Service Information

TC(X) ...

DAP240

Vacuum cleaners without electronic remote control.

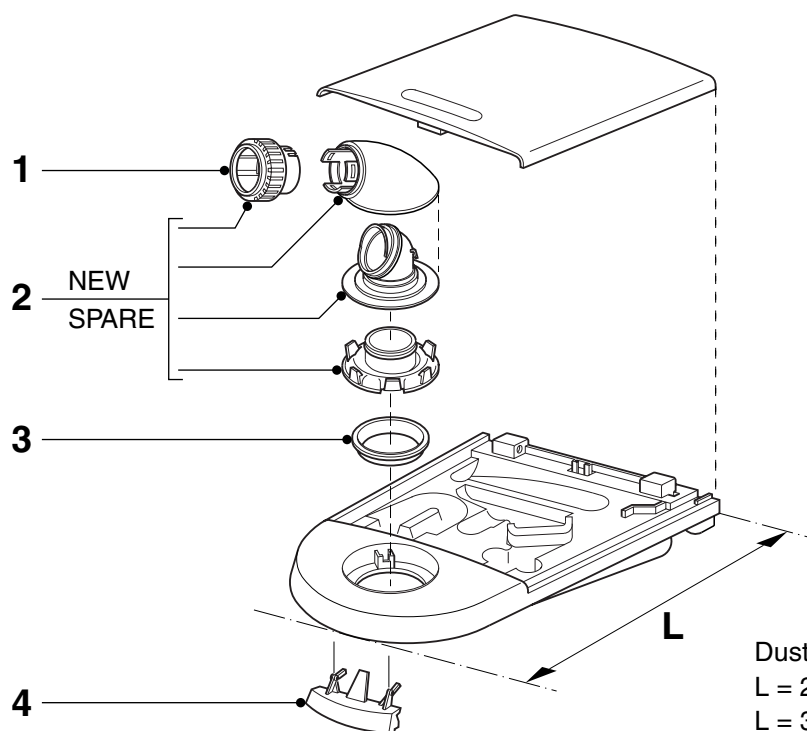
All spare dust covers will be standardised to one colour: black.

In most cases, defective swivels, which are part of the dust cover, can be replaced by breaking them out of the dust cover by means of, for example, a vacuum cleaner tube.

NEW SPARE PART.

Swivel of dustchamber cover has code number: **4322 009 07650**.
